# ALUM ROCK UNION ELEMENTARY SCHOOL DISTRICT

## Addendum 2

Client: Alum Rock Unified School District  
Project: Ben Painter and William Sheppard Fencing Project  
DSA #: 01-121931 – William Sheppard MS Fencing Project  
01-121192 – Ben Painter ES Fencing Project  
Regards: Bid Documents  
Purpose: Addendum #2

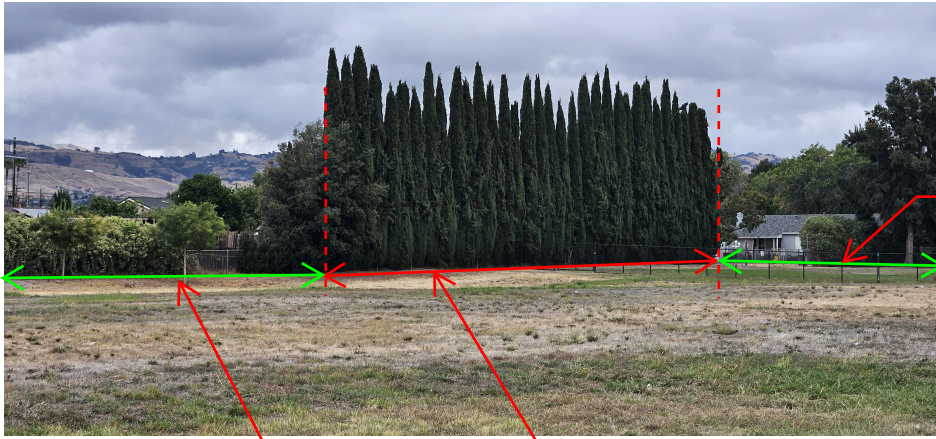
**Question 2:** Please confirm starting and ending points of fence near tree line along property line.

TRIM VEGETATION AS  
NEEDED FOR FENCE  
INSTALLATION

NO FENCE IN THIS AREA  
TRIM VEGETATION AS  
NEEDED FOR FENCE  
INSTALLATION

TRIM VEGETATION AS  
NEEDED FOR FENCE  
INSTALLATION

NO FENCE IN THIS AREA

TRIM VEGETATION AS  
NEEDED FOR FENCE  
INSTALLATION

- **See attached and Addendum 1.**
